UNITED STATES PATENT AND TRADEMARK OFFICE

| APPLICATION NO. | FILING DATE | FIRST NAMED INVENTOR | ATTORNEY DOCKET NO. | CONFIRMATION NO. |
|-----------------|-------------|----------------------|---------------------|------------------|
| 10/772,481 | 02/05/2004 | David J. Coxon | 02-ELT-833 | 4981 |

| Office Action Summary | Application No. 10/772,481 | Applicant(s) COXON ET AL. | |

DETAILED ACTION

Annotated Sheet

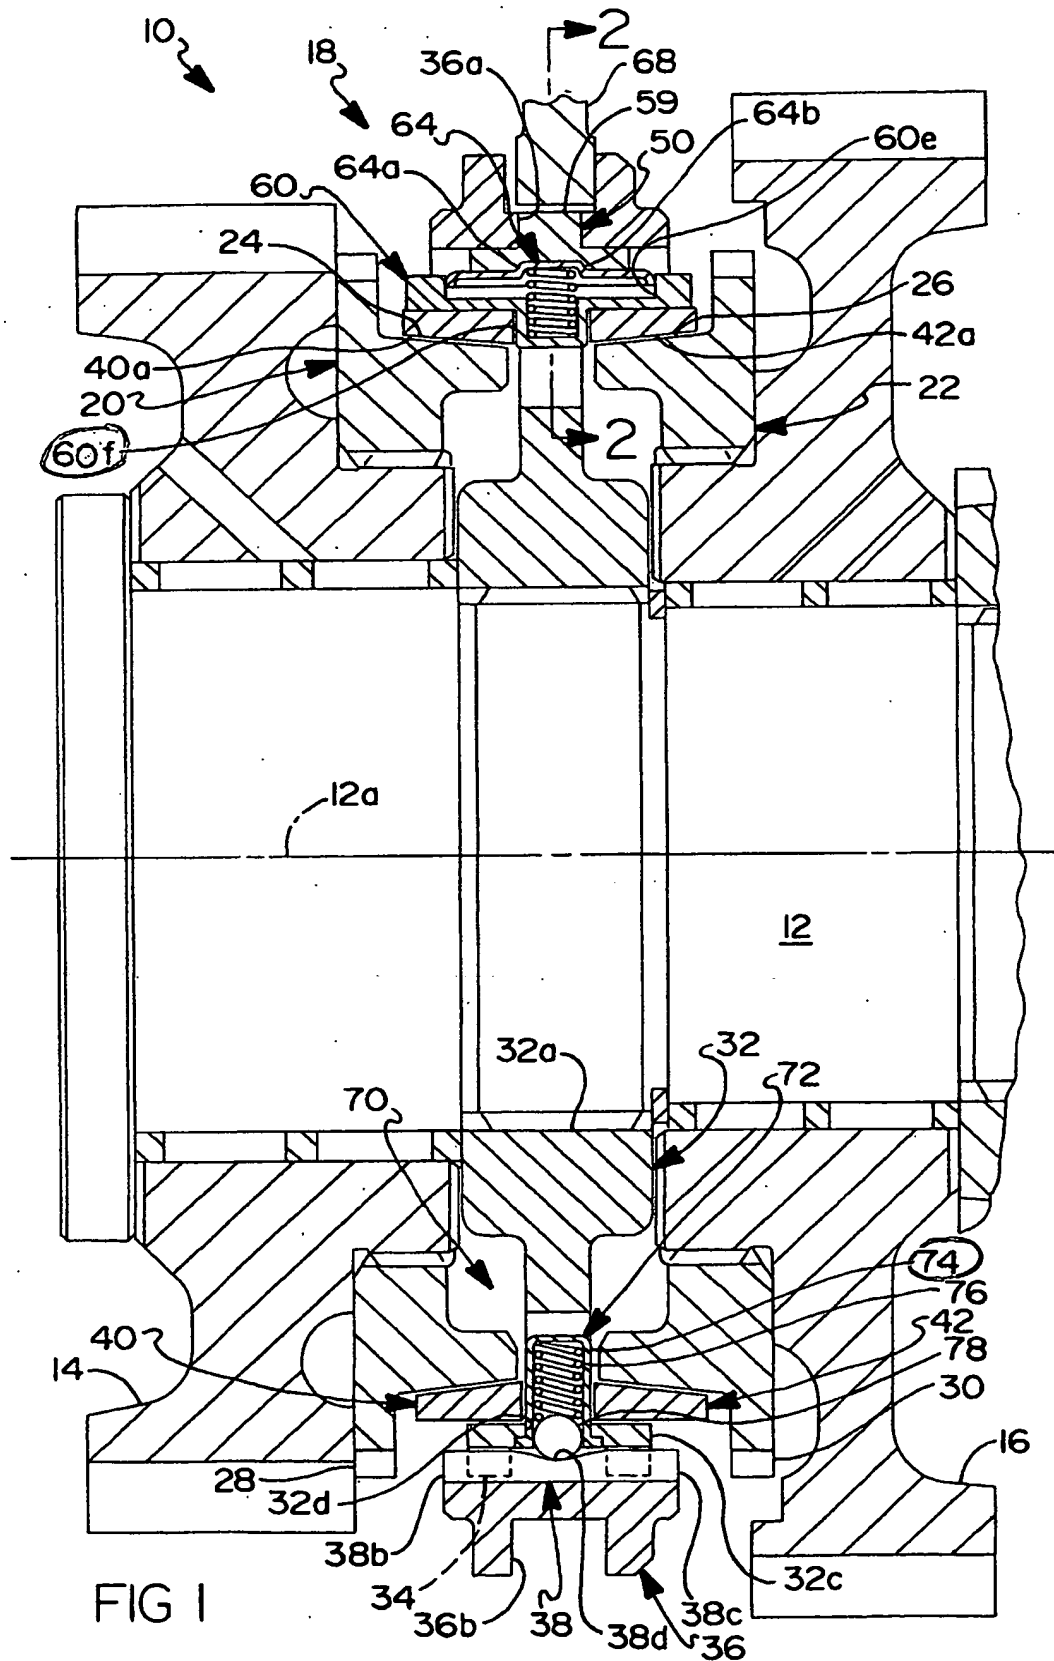
The replacement sheet of drawings and the annotated sheet of drawing showing proposed changes were received on March 16, 2006. These proposed changes and the replacement sheets of drawings are approved by the examiner.

Approved
RHB
4/18/06
